**#2023-04
INVITATION TO BID
AIRPORT FUEL TANKS INSTALLATION
FOR
SOUTHERN WISCONSIN REGIONAL AIRPORT
ROCK COUNTY, WISCONSIN**

**ADDENDUM #1
QUESTIONS / ROCK COUNTY RESPONSES**

Attachment #1 – Site Map

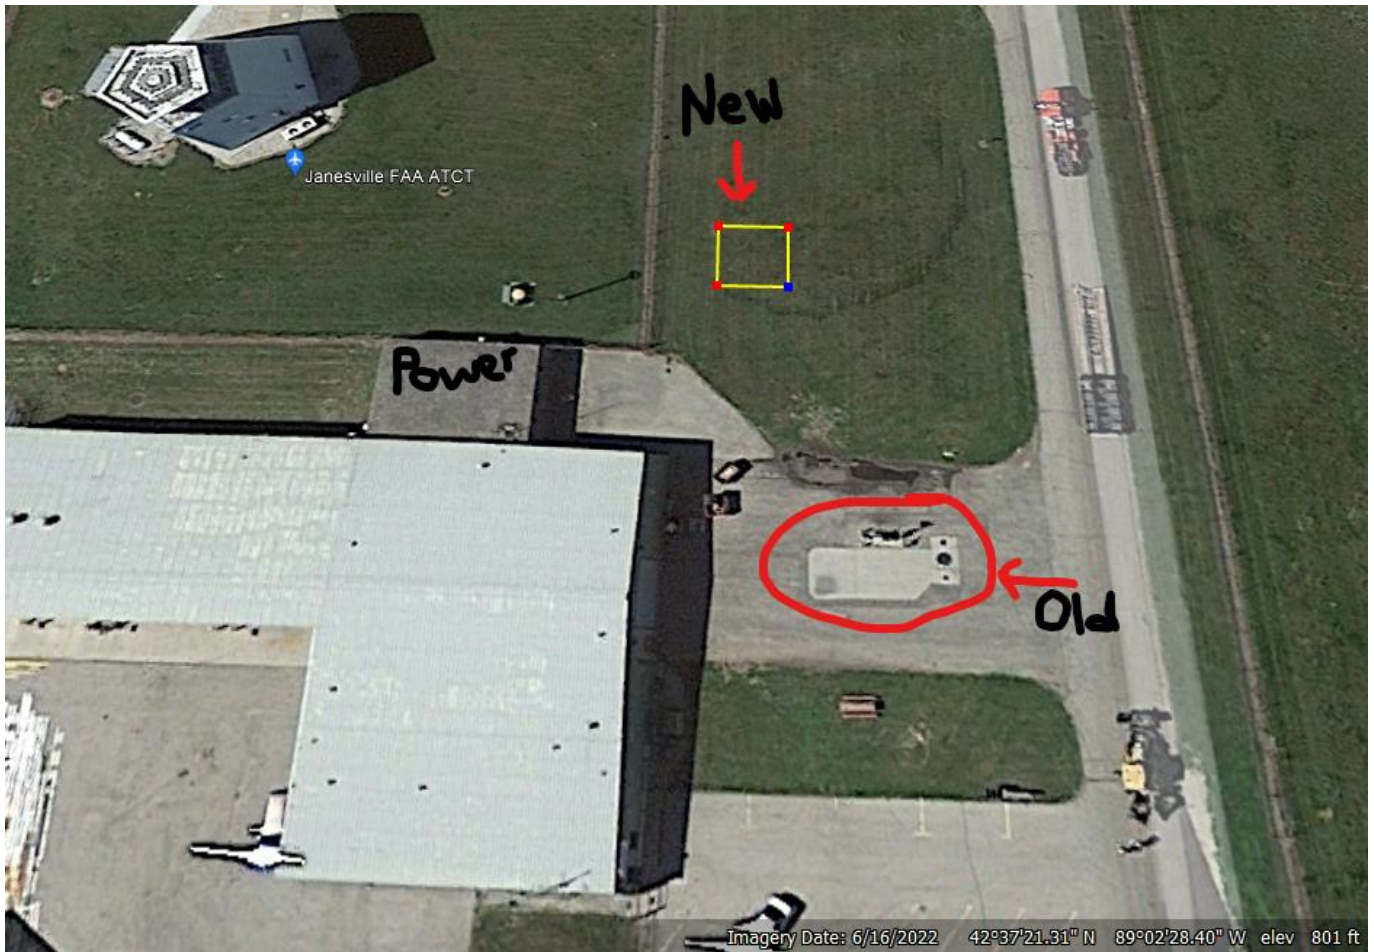
11. Is the new fuel site over 100' from a private well? **Yes**
12. Is the new fuel site over 1200' from a municipal well? **Yes**
13. Where at the Airport is the fuel system located and will the new tanks and pumps be installed in the same location? If not, where will the new fuel system be located? **See Attachment #1- Site map.**
